Model: AI-P2	Date: 28-Sep-12	No.: RM132001a
--------------	-----------------	----------------

Subject: Firmware Release Note: Engine		Prepared by: T. Hirakawa	
From: 2nd Tech Service Sect., MFP/Printer Tech Service Dept.			
Classification:	<input type="checkbox"/> Troubleshooting <input type="checkbox"/> Mechanical <input type="checkbox"/> Paper path <input type="checkbox"/> Product Safety	<input type="checkbox"/> Part information <input type="checkbox"/> Electrical <input type="checkbox"/> Transmit/receive <input checked="" type="checkbox"/> Other (Firmware)	<input type="checkbox"/> Action required <input type="checkbox"/> Service manual revision <input type="checkbox"/> Retrofit information <input checked="" type="checkbox"/> Tier 2

This RTB has been issued to announce the firmware release information for the **Engine**.

33.Fusing Unit 3 (D129/D130)

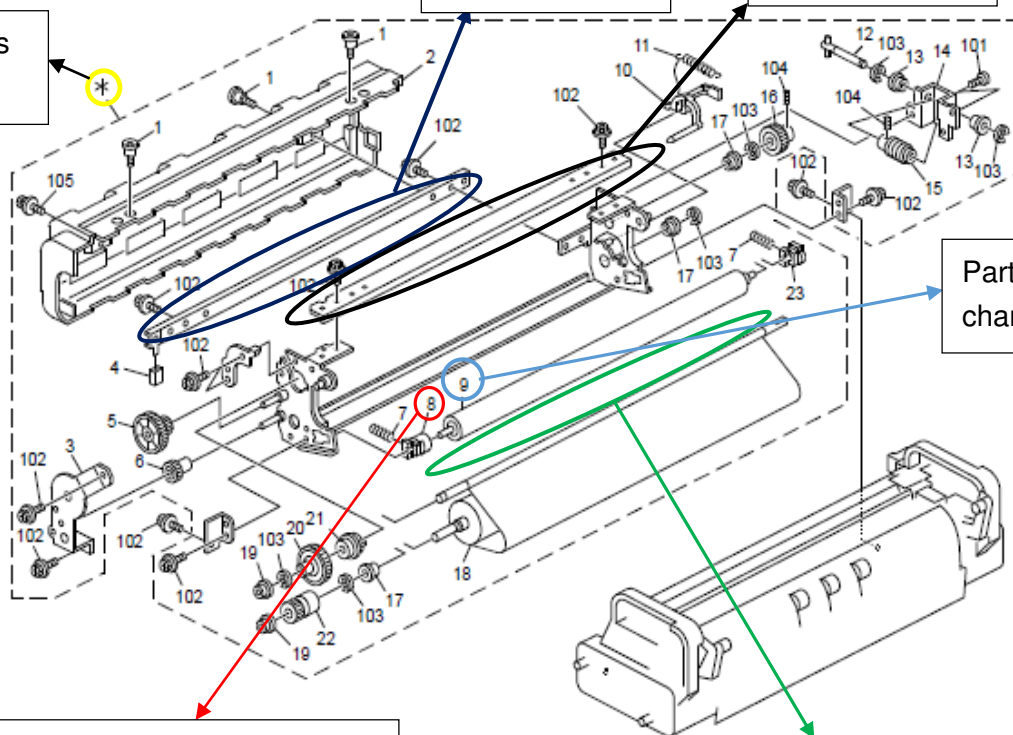
Change/Reason: To prevent the cleaning web from coming loose, the following parts are changed or newly added to the fusing unit.

Part number is changed

29** is added.

30** is added.

Part number is changed

This is deleted.
Instead, 26** and 27** and
28** are added for [2].

24** and 25** are added
for [1].

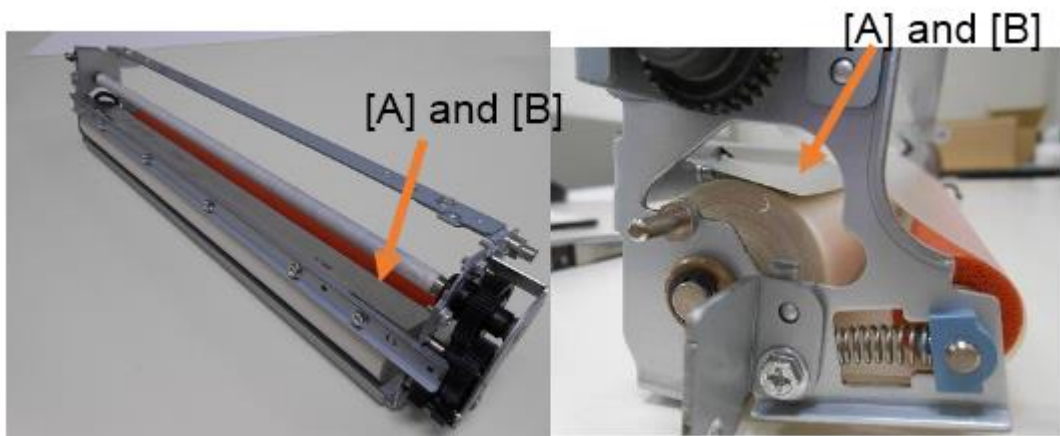
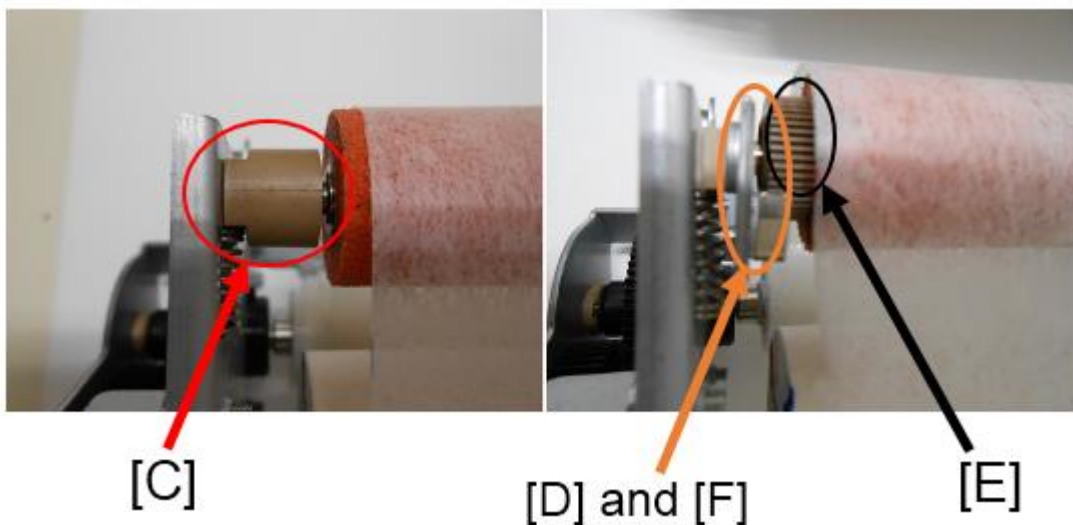
[1] Variable brake

[A] and [B] are the variable brake.

[2]: One way clutch method

One-way clutch method is before.

Ratchet method is after.

Please install a new cleaning unit (p/n: D1294304) when a cleaning web issue occurs, because individual parts are not compatible due to modification of a frame on the fusing unit. After that, individual parts can be replaced.

31. Electrical Section 4 (M132)

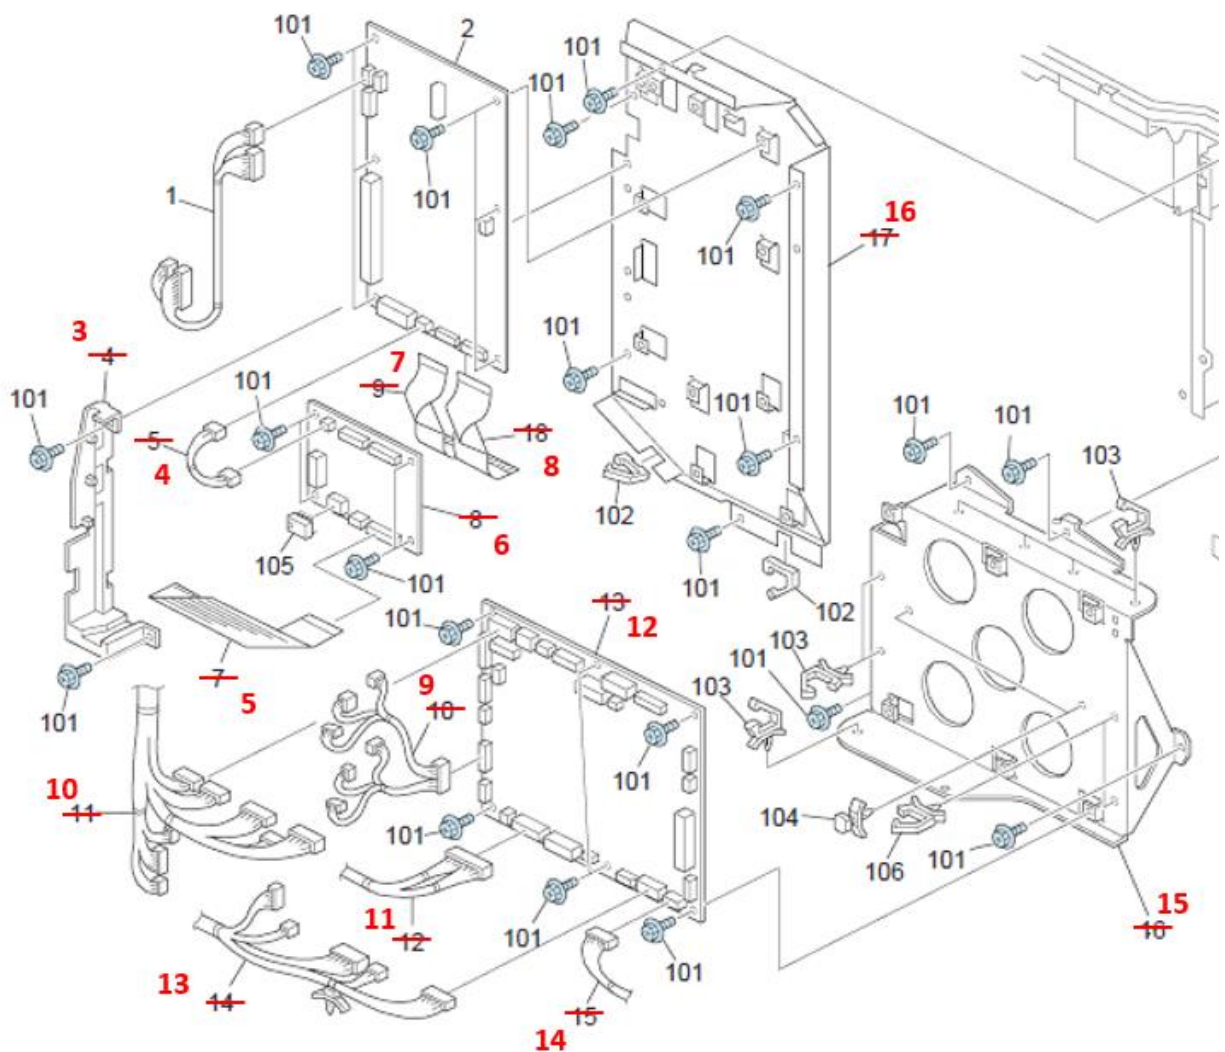
The index numbers in Electrical Section 4 (page.61) were corrected as follows.

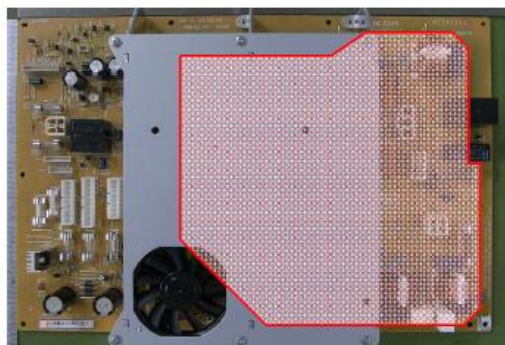
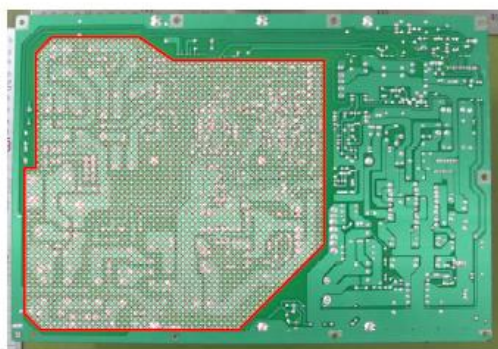
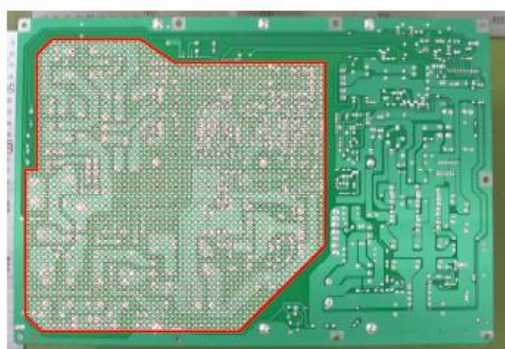
Please add the following caution note in the field service manual in this section:

NEVER touch the areas outlined in red in the photos below to prevent electric shock caused by residual charge.

Residual charge of about 100V-400V remains on the PSU board for several months even when the board has been removed from the machine after turning off the machine power and unplugging the power cord.

The areas outlined in red on the bracket show where the residual charge of about 100V-400V remains on the PSU board under the bracket.

1.BRIDGE UNIT 1 (D634)

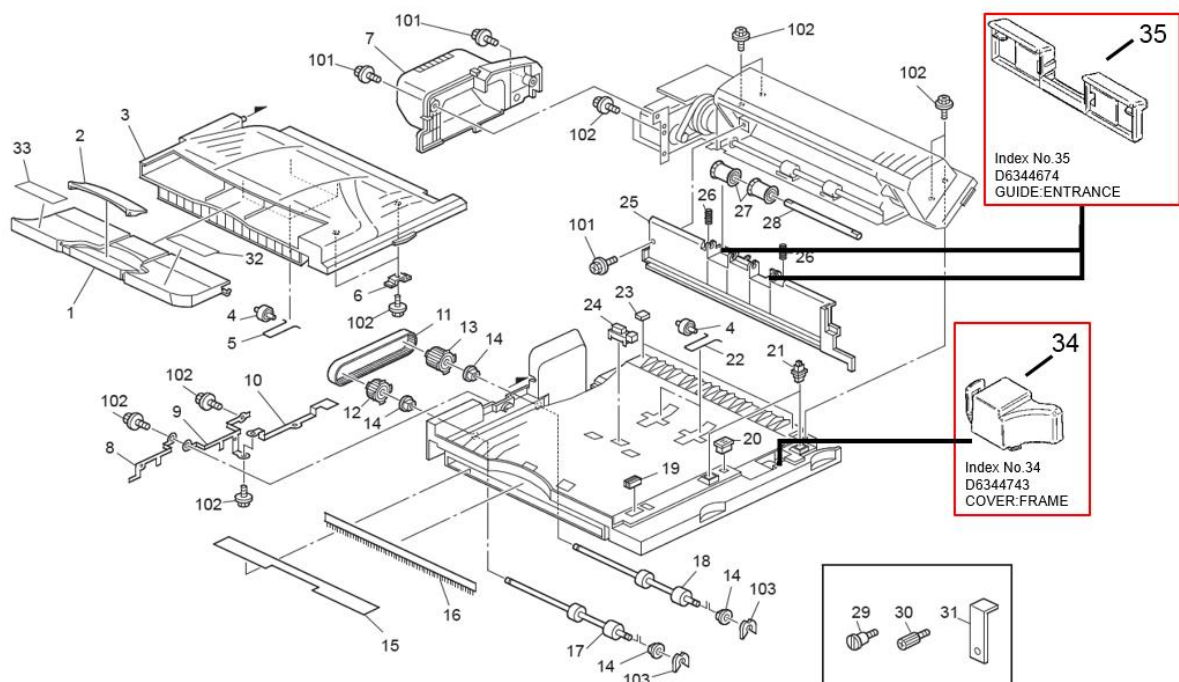
Change: Illustrations of the following parts were added to the parts catalog.

Part number	Description	Q'ty	Page	Index	Note
D6344743	COVER:FRAME	1	3	34	
D6344674	GUIDE:ENTRANCE	1	3	35

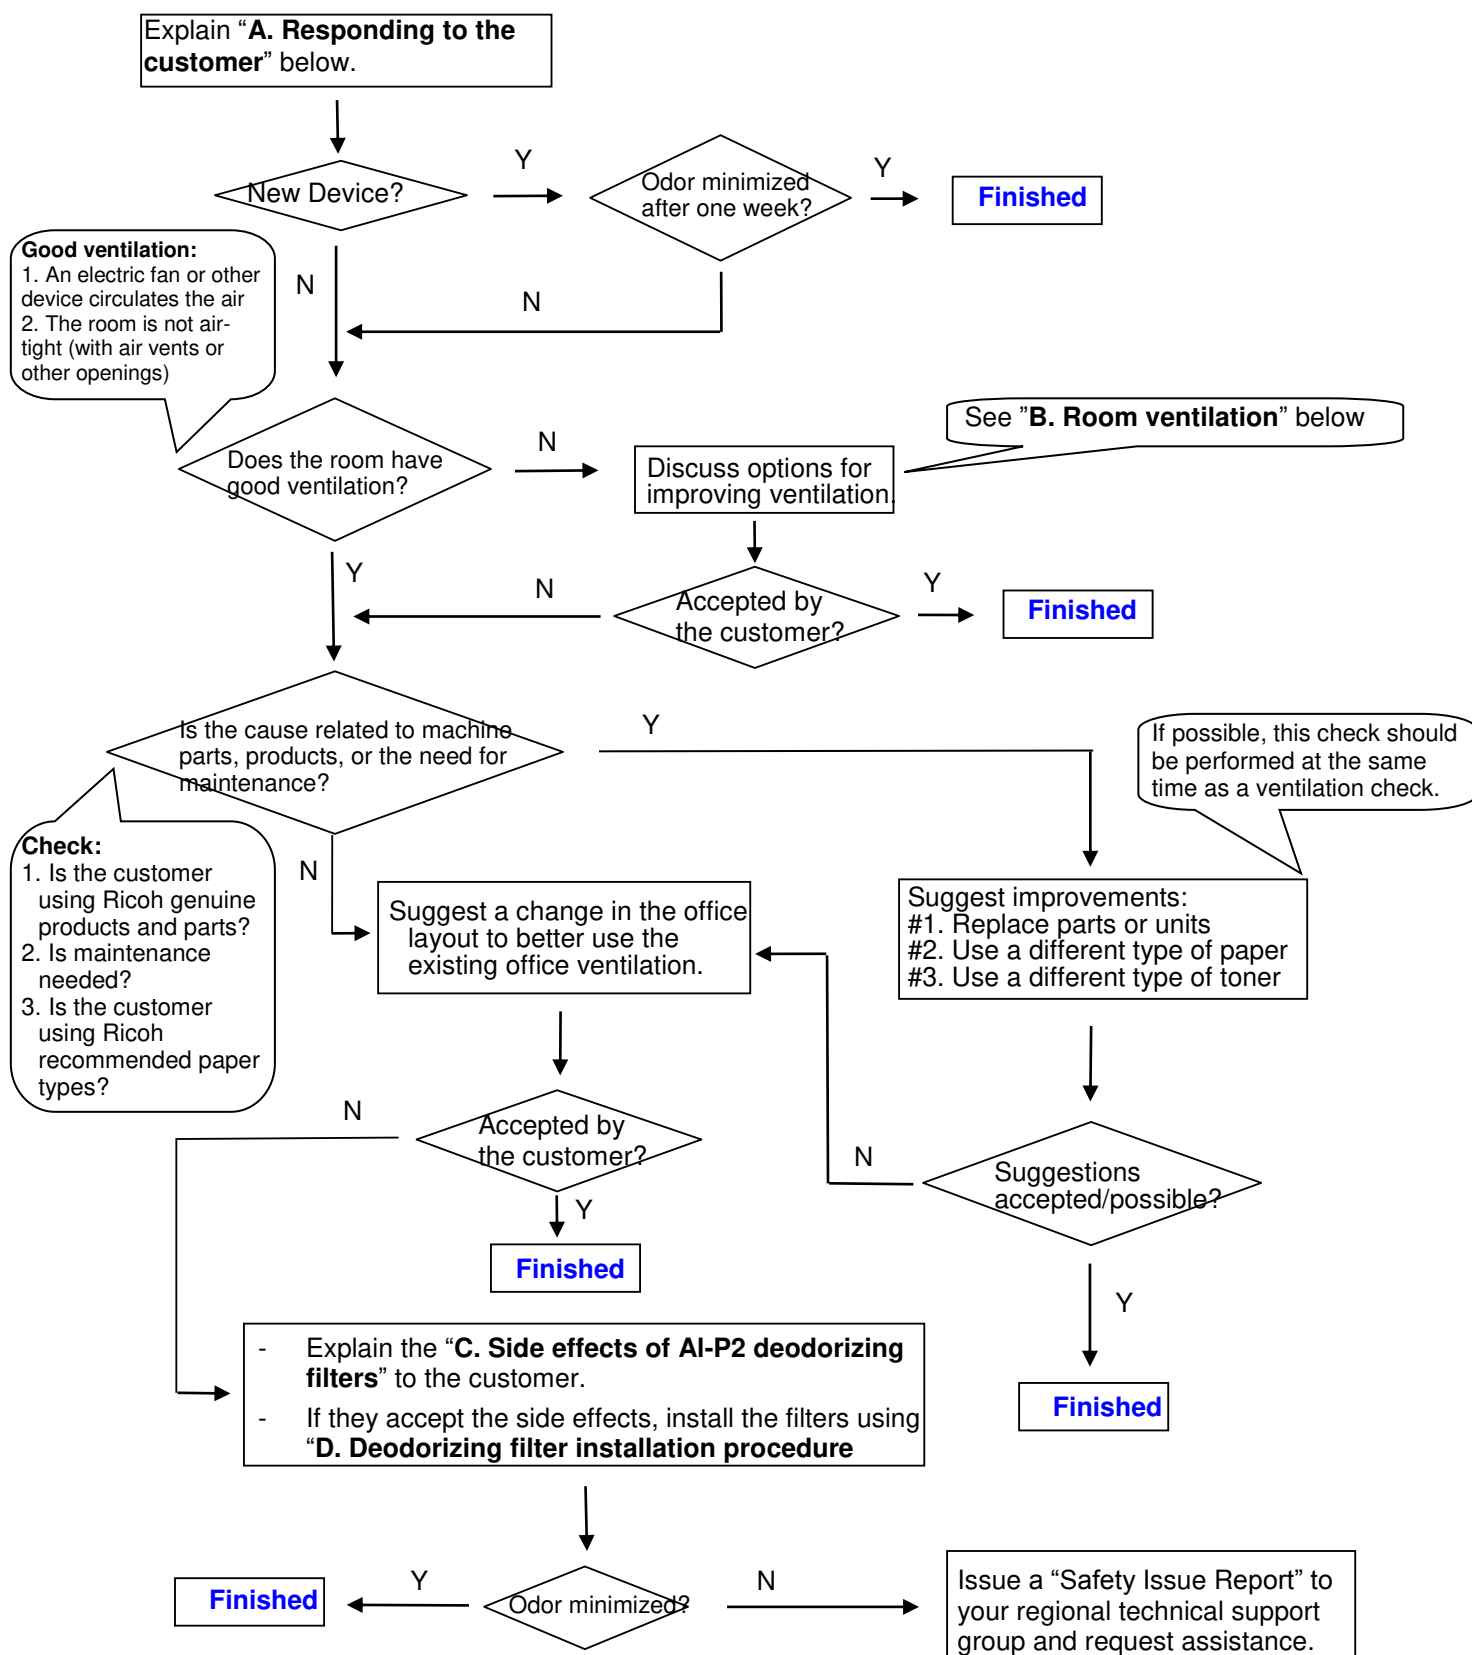
Change: Deodorizing filters were newly added as service parts for the AL-C1/AL-C1.5/AL-C2/AL-P1/AL-P2.

Reason: To meet the requests of customers who may report strange odors on these models.

If a customer reports a strange odor on the machine, use the **flowchart below** to take the appropriate action.
